Our File No. S-240-99

Our File No. S-114-97

RE: STRATA PLAN LMS 572 -- BIRCH GARDENS
1318 WEST 6TH AVENUE, VANCOUVER, B.C.
- BUILDING ENVELOPE ASSESSMENT

REPORT
ON
BUILDING ENVELOPE ASSESSMENT
AT
STRATA PLAN LMS 572 -- BIRCH GARDENS
1318 WEST 6TH AVENUE, VANCOUVER, B.C.

Photo No. 1 and 2

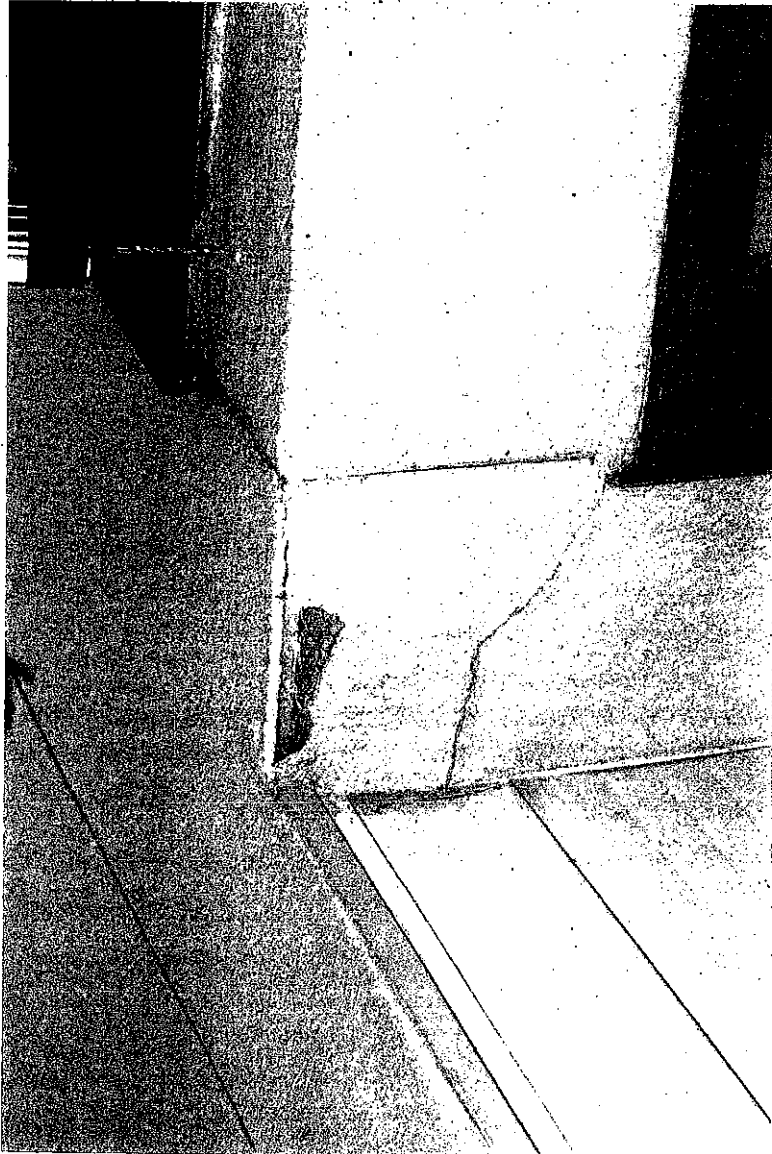
- .6 We then removed a section of the interior gyproc directly above the rotted floor area. Moisture was noted entering the suite through the cold joint between the concrete slab below the exposed aggregate sidewalk and the concrete upstand of the exterior wall. This indicates a membrane breakdown at this intersection.

- .7 The sheathing and framing members of the exterior wall in this location are completely deteriorated (Photos No. 1 and 2).

- .1 This is an isolated problem. To repair this area, sections of the exposed aggregate topping of sidewalk and the stairs to Suite 307 will require removal.
- .2 The waterproof membrane below these areas will require redoing to ensure a proper tie-in between concrete slab and upstand wall.
- .3 Sheathing and framing members in this area will require replacement.

Photo No. 3 and 4

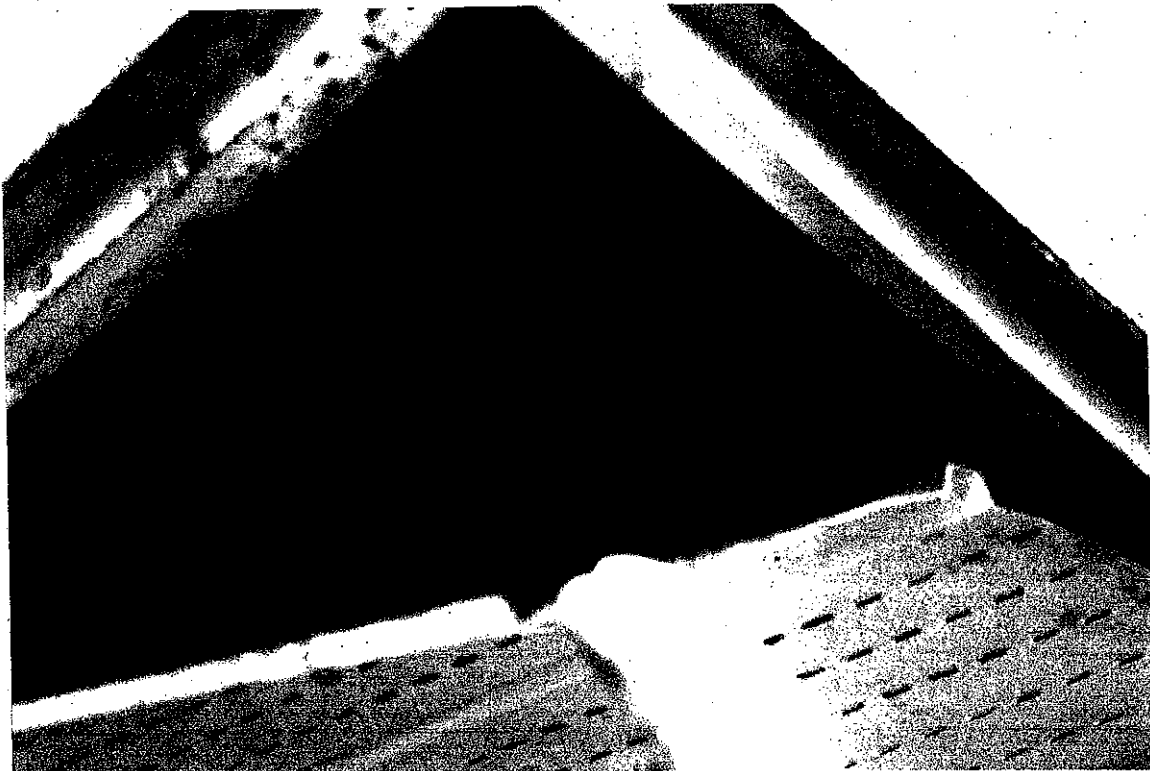
- .1 Stucco at the lower corners of the bay windows are soiled badly.
- .2 The vertical joint at the jambs have not been caulked. The stucco stop that forms this joint terminates at the top of the sill flashing. With this joint not caulked, water is being channelled behind the stucco at this jamb-to-flashing intersection.
- .3 Moisture readings were taken just below the sill flashings at this intersection. A high reading of 35% was received, which indicates the exterior sheathing, at a minimum, is deteriorated.
- .4 For a comparison reading, we probed the wall just below the 2nd Floor bay window to the west of the first area. A reading of 33% was received. We then removed the stucco in this location, and found that the exterior sheathing was completely deteriorated (Photo No. 3).
- .5 Photo No. 3 also shows how the vertical plaster stop terminates at the sill flashings.

.4 The framing of the 3rd Floor deck was viewed by removing the soffit material, and framing deterioration was noted (Photo No. 4).

- .1 Remove 6-8 inches of stucco from the head and jambs of windows.
- .2 Inspect and replace sheathing and framing as required.
- .3 Repair building papers and apply peel-and-stick membrane from flange of window to building paper.
- .4 Install plaster stops at the jambs of windows to form a proper rod and caulk joint.
- .5 Install new through-wall head flashings.
- .6 The repairs for bay windows and skylights would be the same as noted above.
